FVA industry sub-group on technical requirements

01.09.2022

Summary for goals & next steps (1/2)

JAMA V4 violation examples of series HUD HMI #2

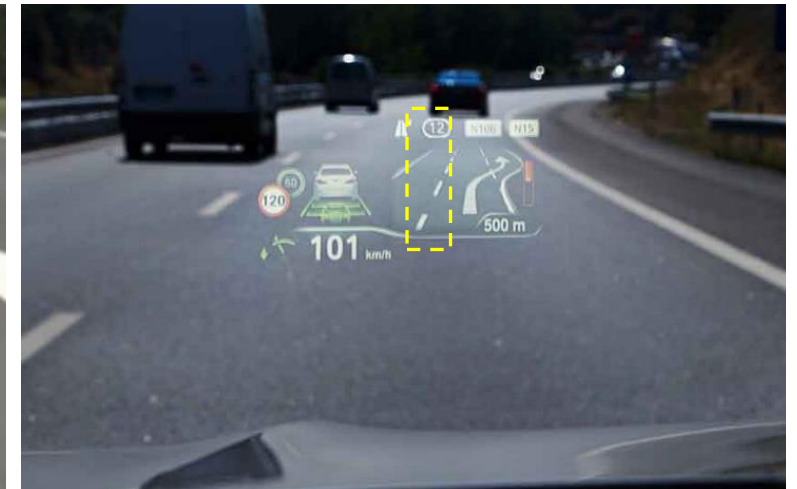
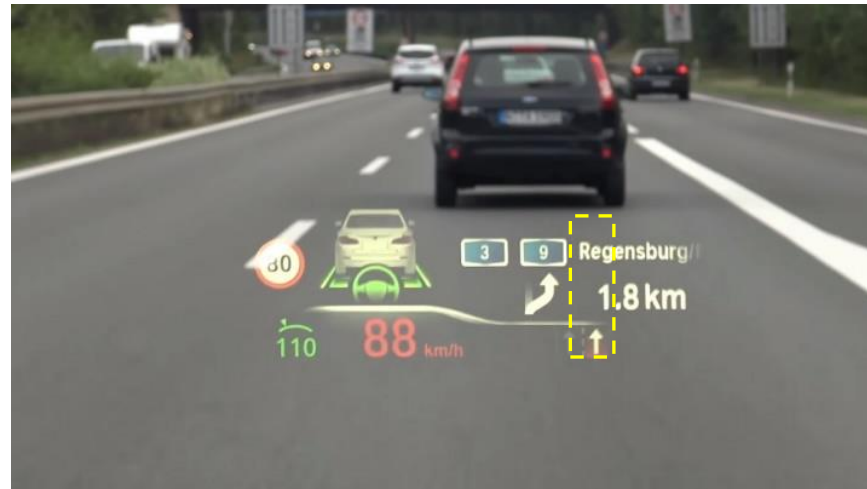
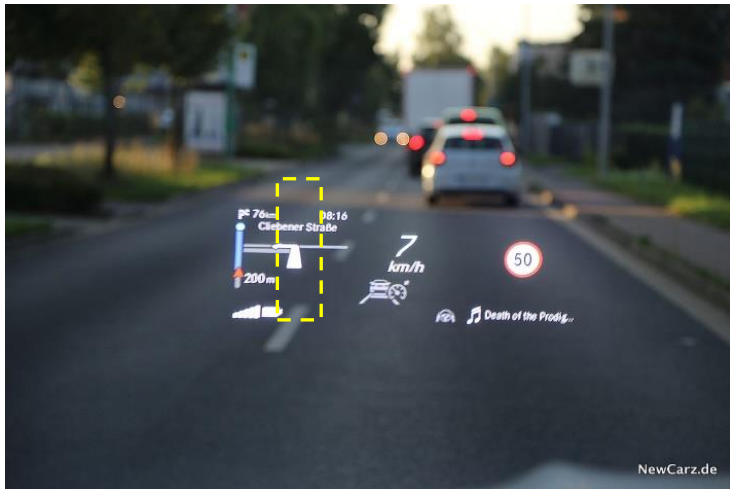
violating JAMA V4 envelope (7x)
violating JAMA V4 red criteria

questioning the envelope concept in detail

Is it true that with such clean HMI concepts a pedestrian in size of yellow box (basic figure: $2,6^\circ \times 0,8^\circ$) could **not** be seen?

All examples above are static images and do not even consider the relative movement of the car relative to a pedestrian of such size, which will make pedestrians even more recognizable due to constantly changing perspective.

CASE 1: large VID

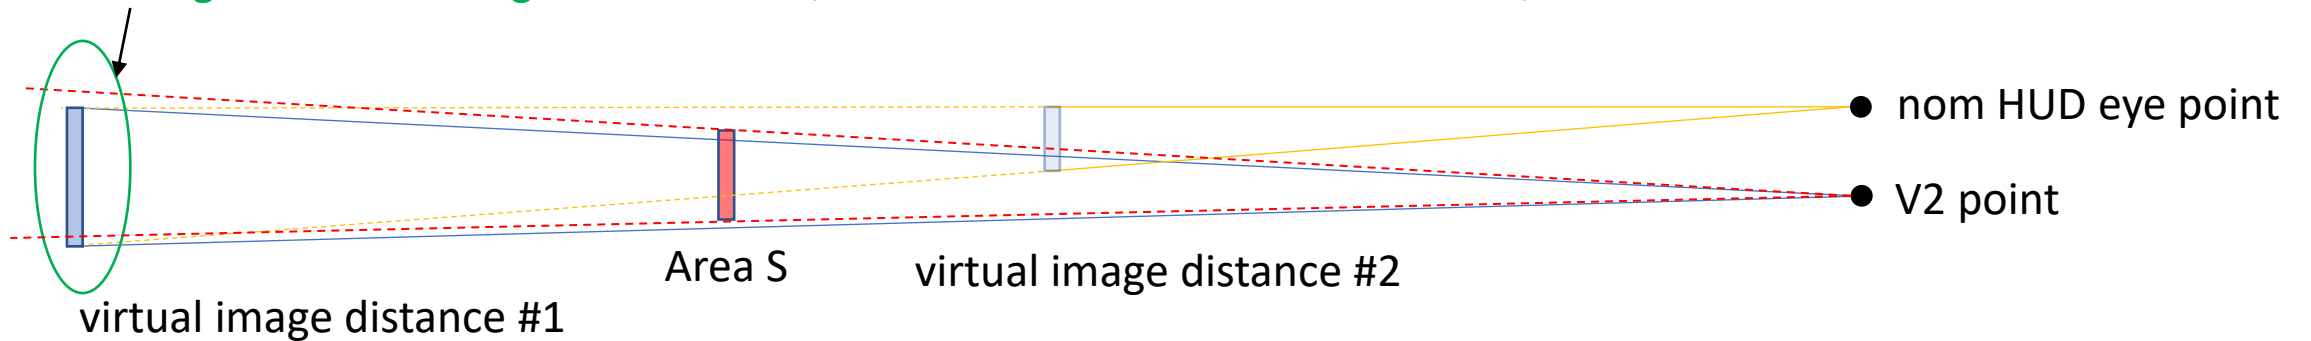
Large VID: VI not regulated as FVA (VI is inside & below Area S when seen from V2)

CASE 2: small VID

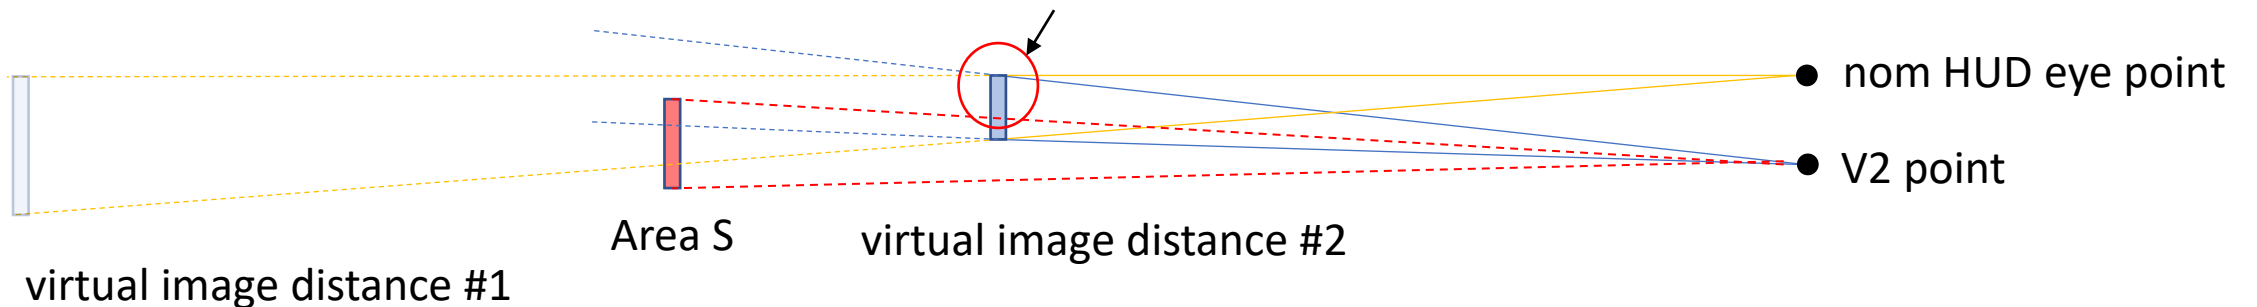
Small VID: 2/3 of VI regulated as FVA (VI is inside and above Area S when seen from V2)

Case 3 & 4: comparison for classic HUD and FVA systems

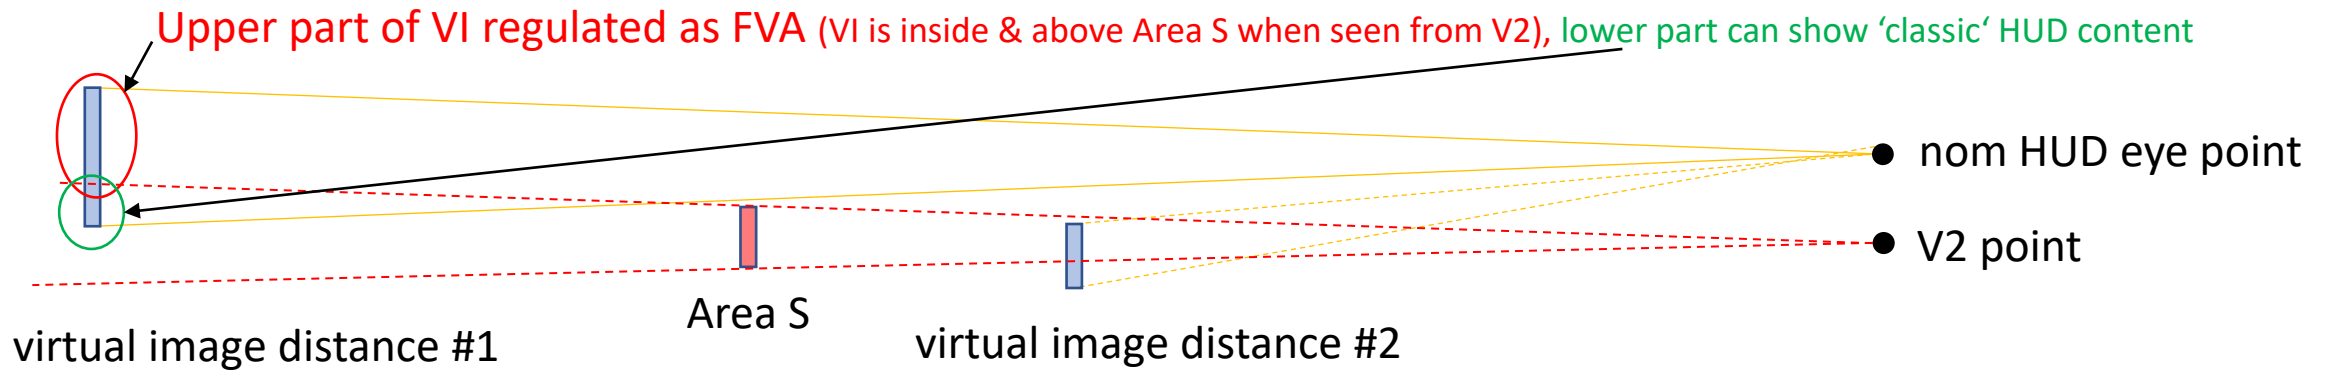
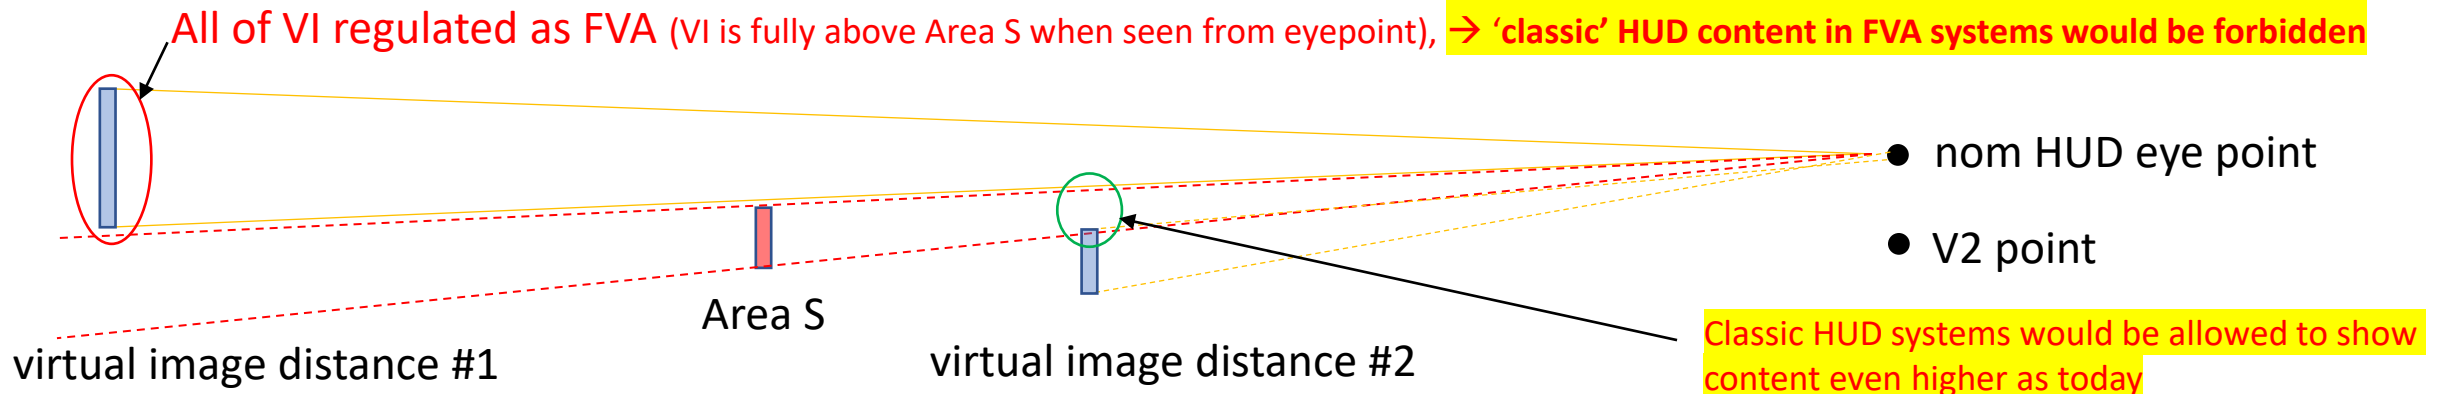
FVA systems typically have a larger VID and less lookdown angle (LD is about -2.5° instead of about -5° for classic HUD systems)

CASE 3: large VID, less LD angle (typical FVA system), investigated from V2 point (current regulation)

CASE 4: large VID, less LD angle (typical FVA system), but investigated from eyepoint instead of V2

Conclusion: Keep the requirement to calculate from V2 point (as currently defined), considering that the parallax error will happen for any object that is not exactly in the same plane (i.e. same distance) as Area S.

This ensures that no potential for worsening classic HUD systems is possible and at the same time keeps the possibility to show classic HUD content (static symbols) within FVA systems in the lower area.

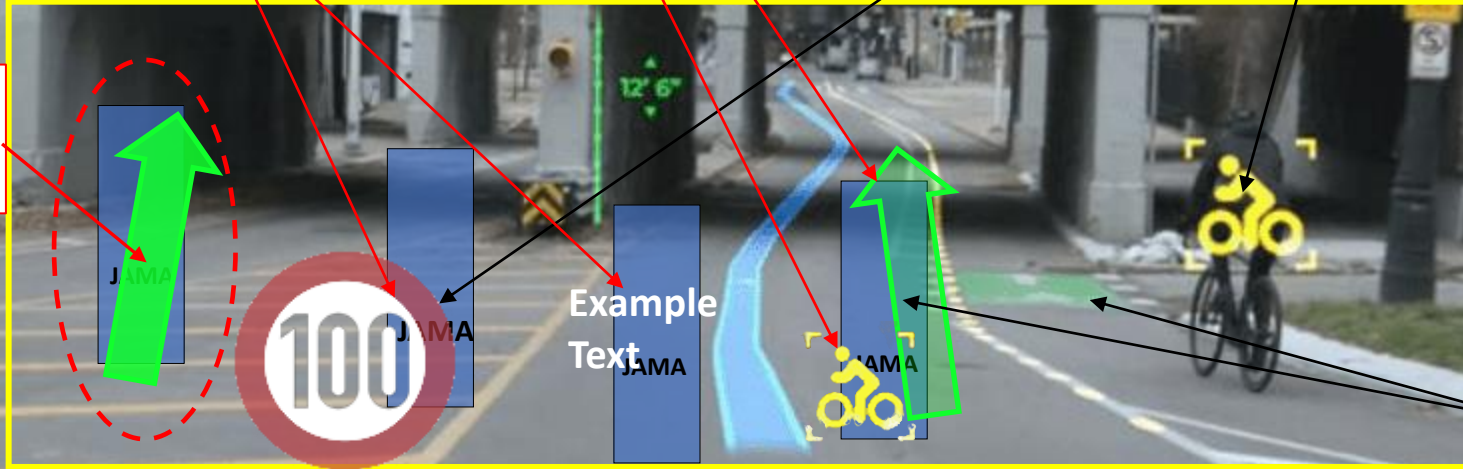
counting as „possibly covering“ of the blue „JAMA rectangles“ because full brightness for given situation and color strongly perceived by human eye (e.g. white, green)

- Bright green outline of arrow
- Full brightness symbols that are **not augmented** onto the object
- White pixels in speed sign and texts

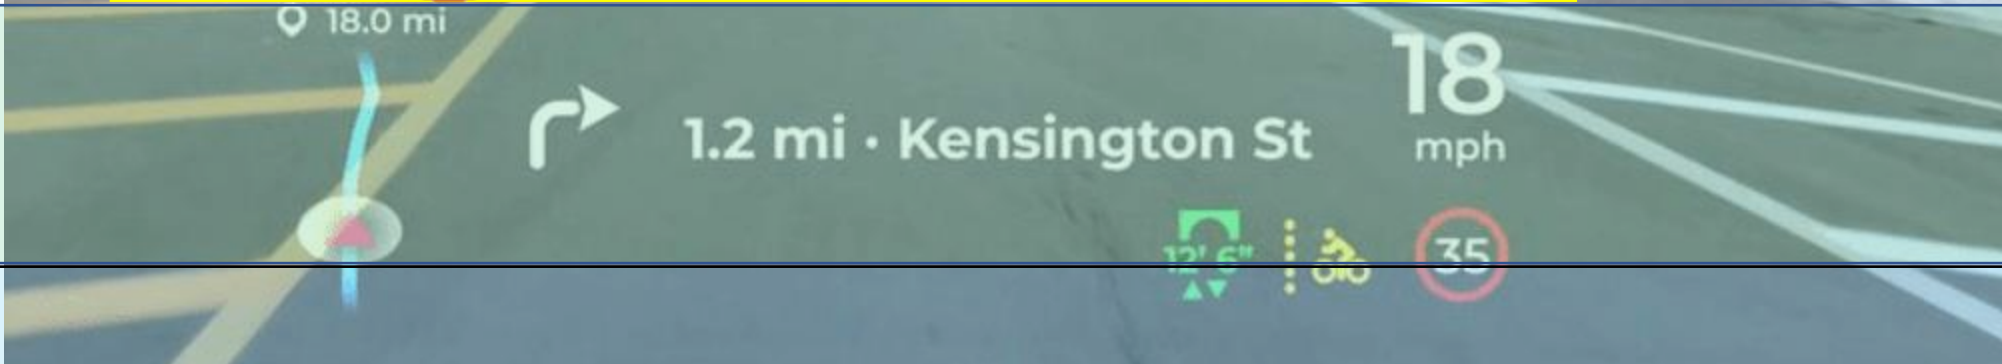
Area S, not regulated as FVA, (but 20% coverage of Area S at maximum)

Below Area S, not regulated as FVA

New approach for discussion: If pixel count of ‚possibly covering‘ pixels overlaying each blue „JAMA rectangle“ in FVA area $\leq 35\%$ -> good
